MEETING NOTICE – SITE REVIEW COMMITTEE

Date/Time: Wednesday February 23rd 2022 (5:30 P.M.)

RE: 550 Centennial Centre Blvd., HB-3208; Wall Signage, Scott's Subs

RE: 565 Larsen Orchard Parkway, HB-3206; New 3,697 Square Foot Commercial Building

A2.0

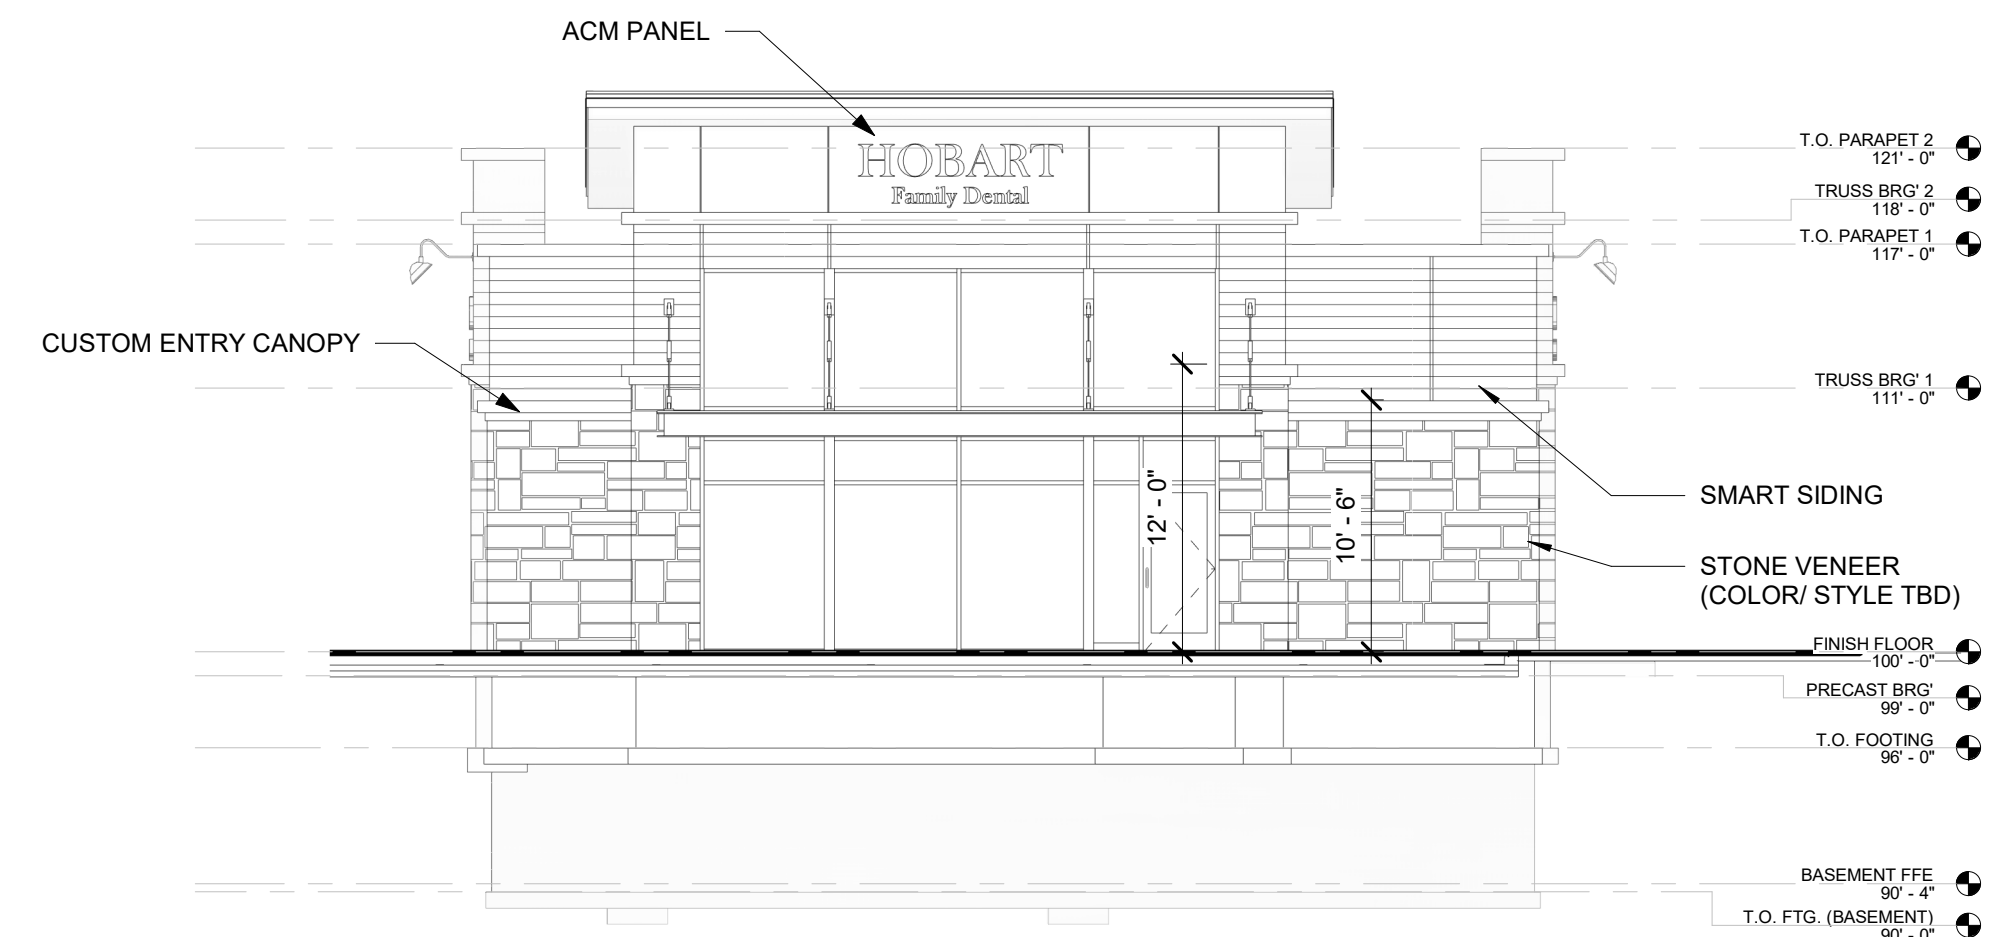
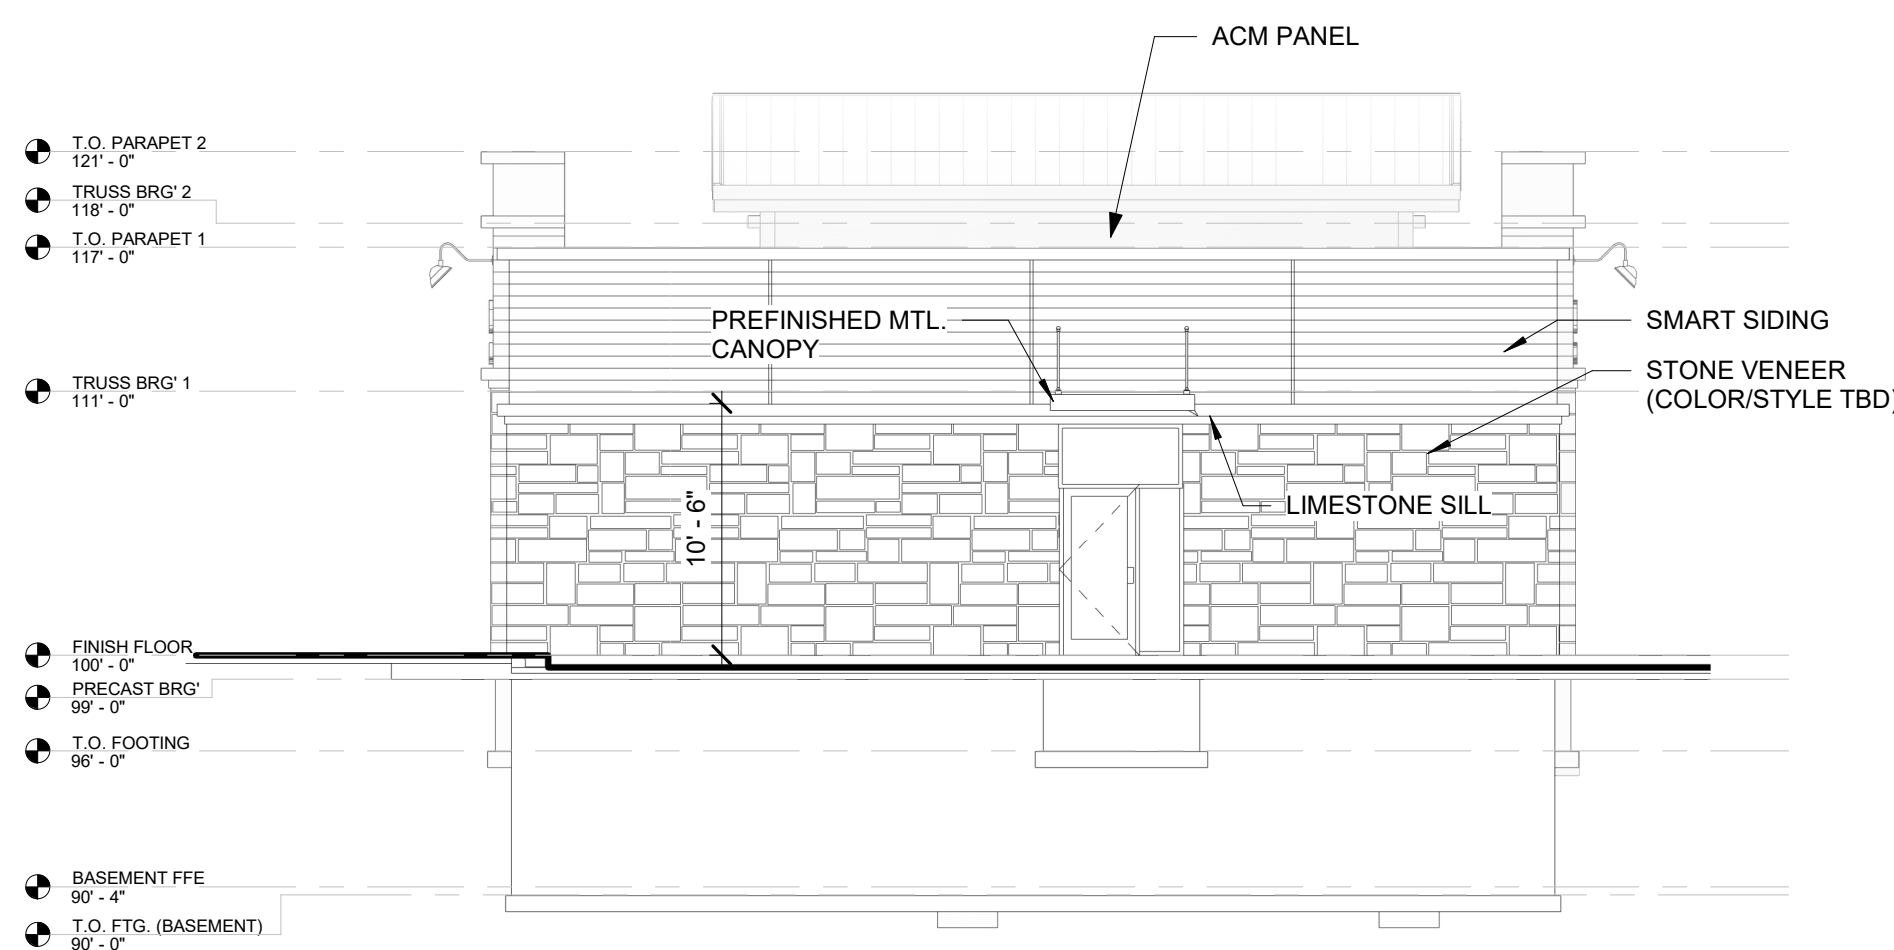
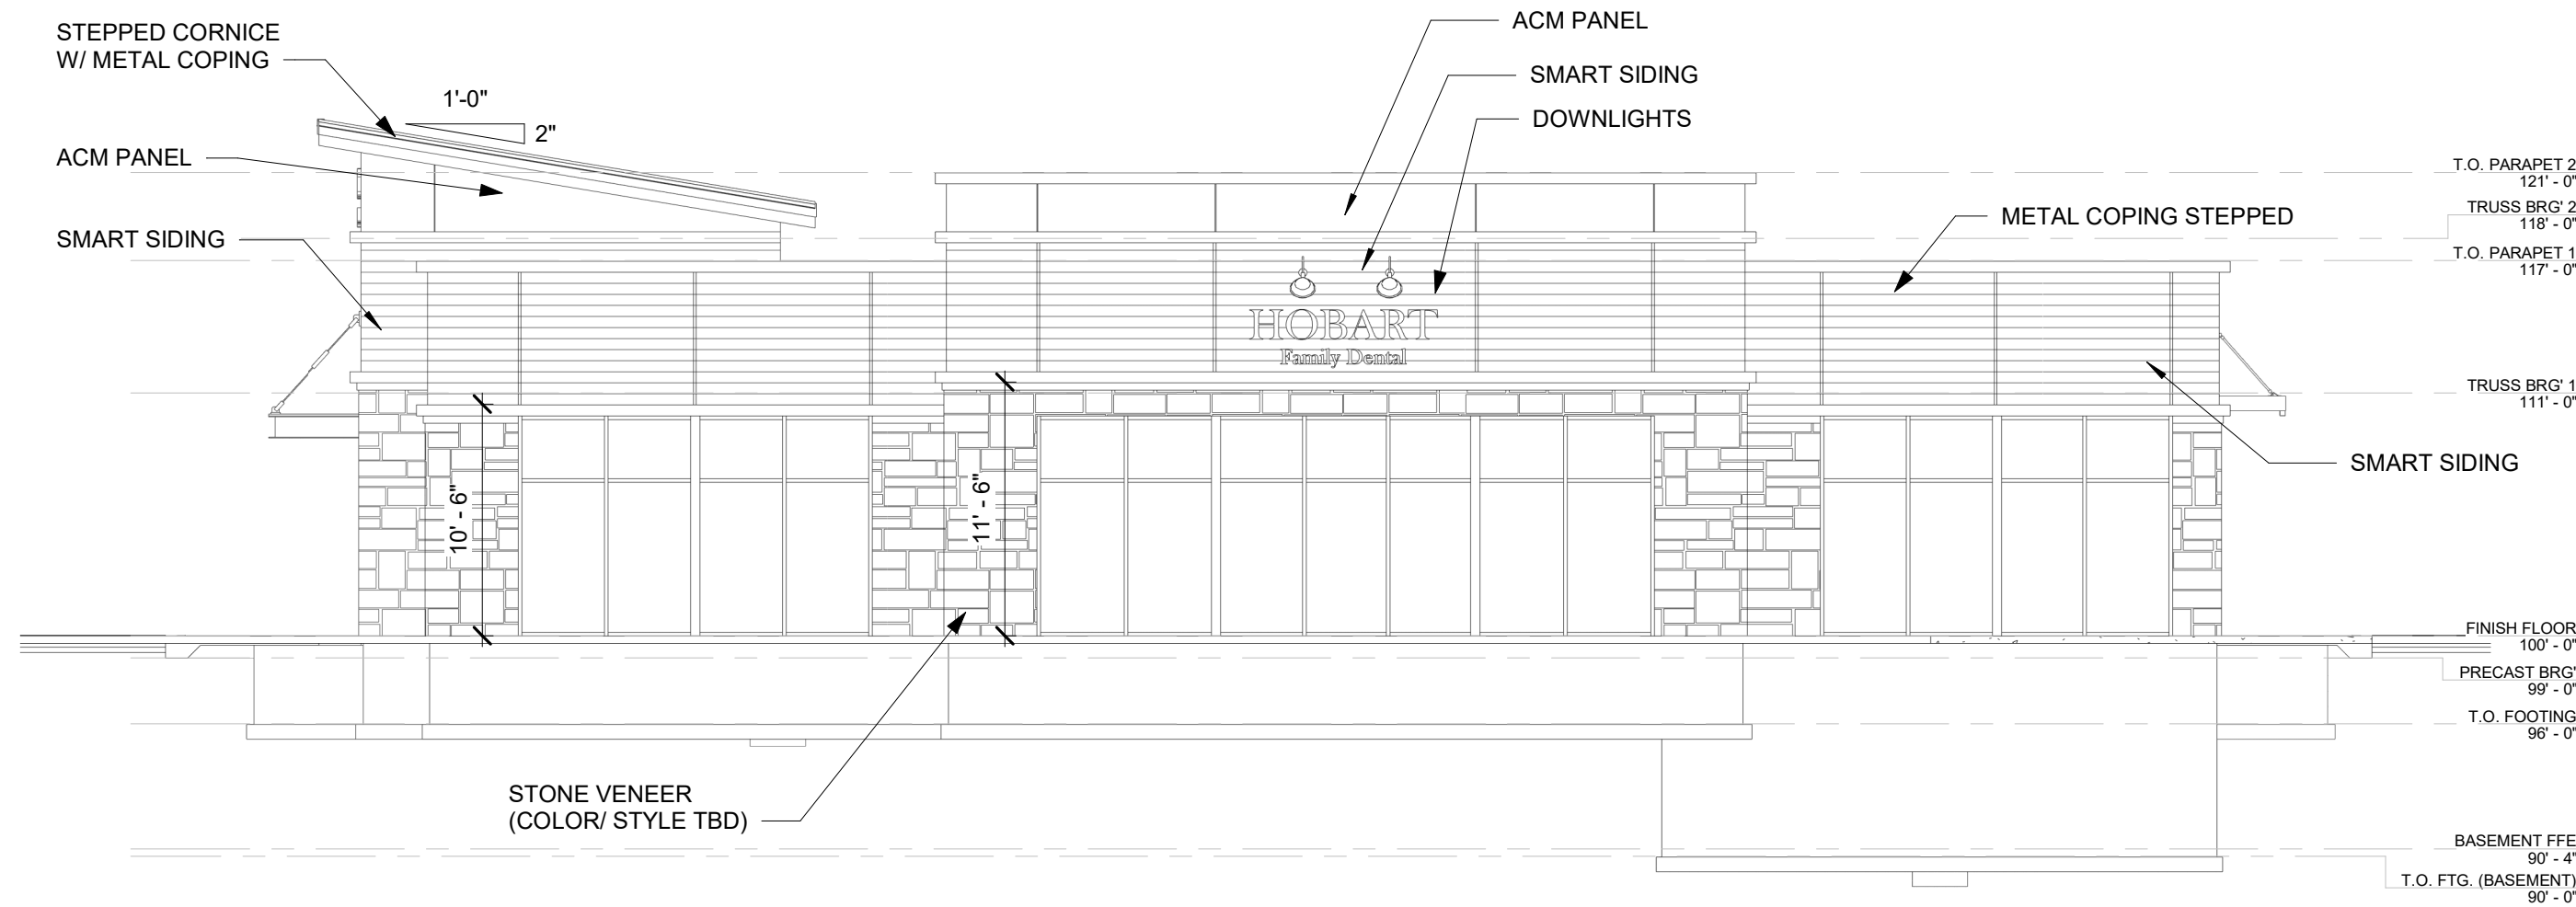
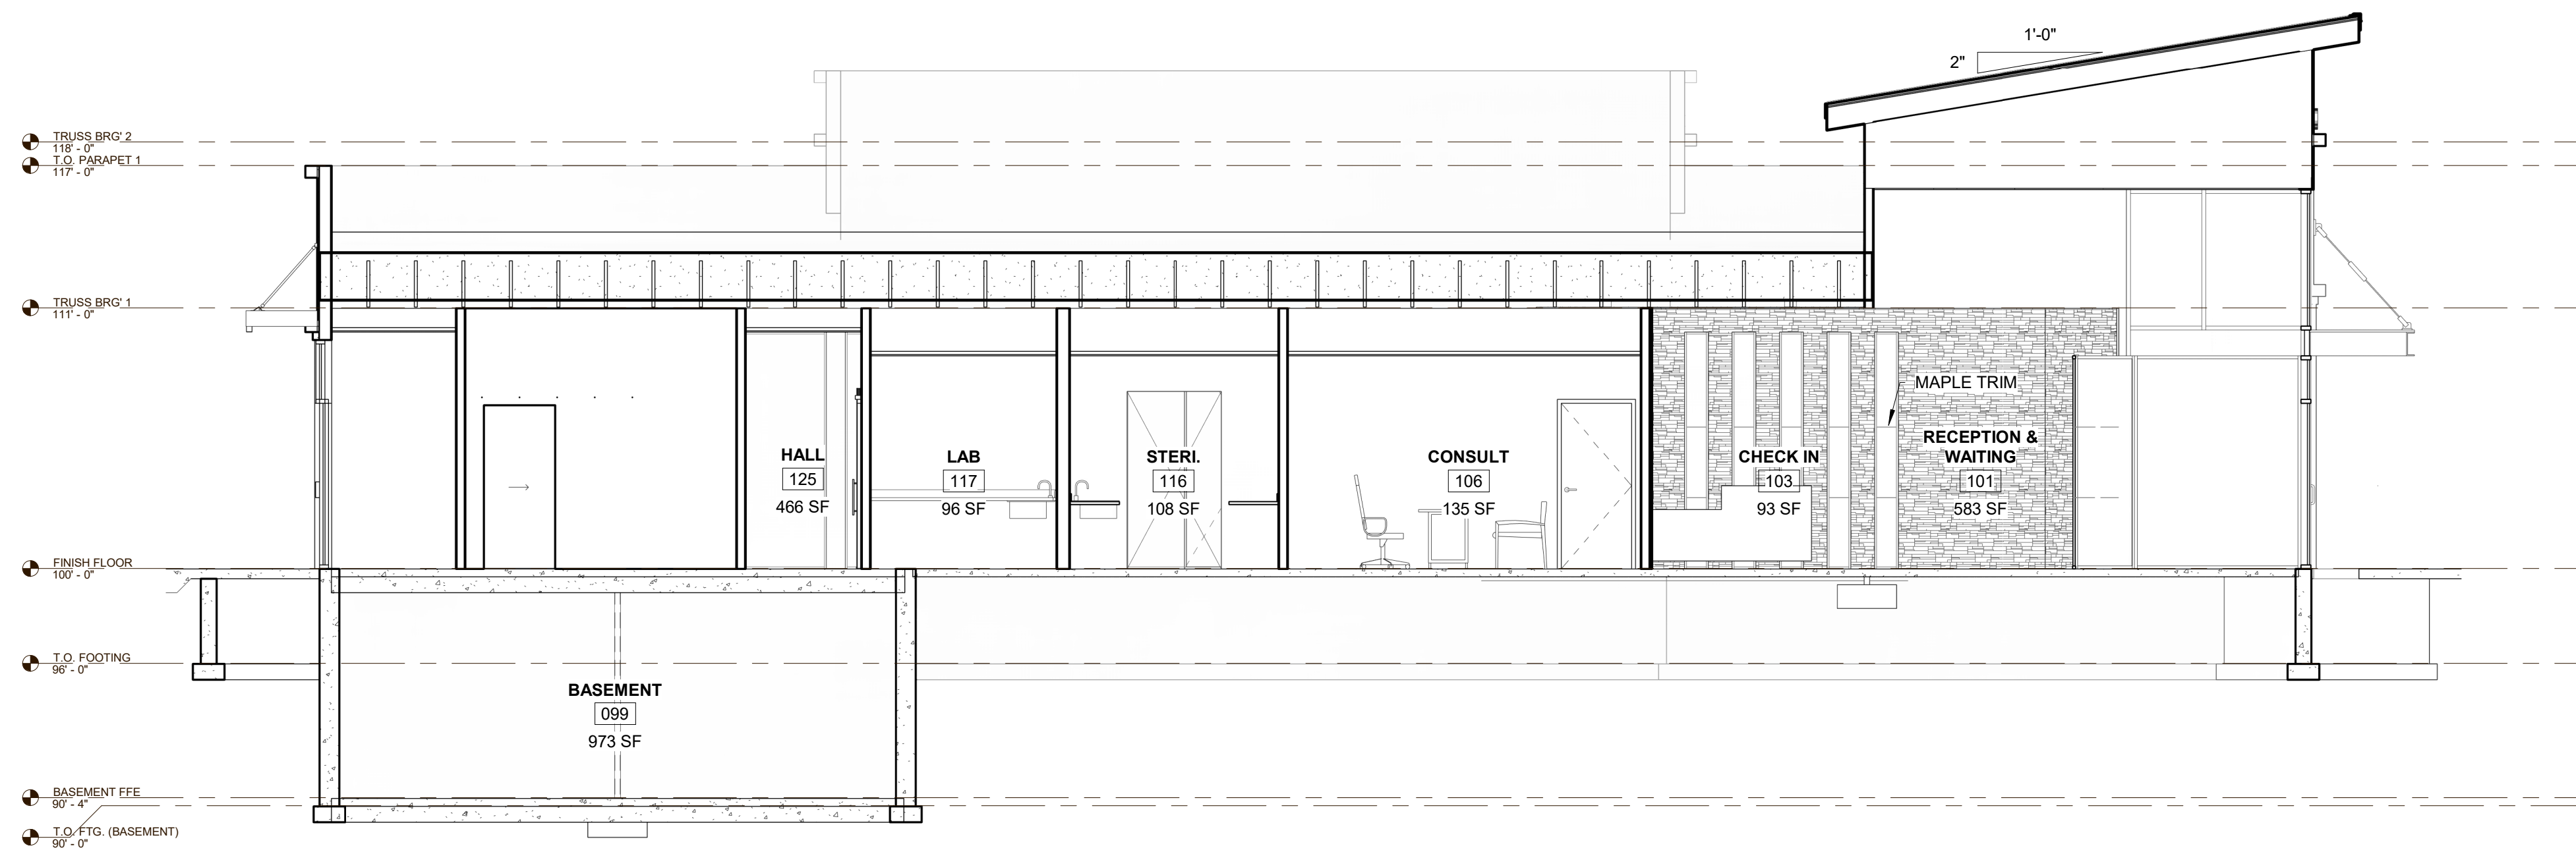
- 1. Materials:** Wood framed building.
- 2. Exterior Materials:** All four building elevations will be similar with approximately 10' high stone veneer, smart siding (engineered wood-based lap siding) above, and ACM (Aluminum Composite Material) accents near the top.
- 3. Height:** 21' to top of parapet wall
- 4. Overhead doors:** None
- 5. Mechanical equipment:** None shown, however, if located on the roof or ground, shall be screen from view by materials compatible with the building or landscaping.

Section 5, Signage: Wall signage is noted on three sides of the proposed building (North, East, and West elevations). However, no sign details are attached so any proposed signage shall be submitted for approval prior to installation.

1. Detailed landscape plan shall be submitted for approval which includes landscaping around building perimeter, and screening for parking areas located in front of the building (along Larsen Orchard Parkway).
2. Details and locations of building mounted lighting and parking lot pole lighting shall be submitted for approval prior to installation.
3. Signage details shall be submitted for approval prior to installation.
4. Any mechanical equipment if located on the roof or ground, shall be screen from view by materials compatible with the building or landscaping.
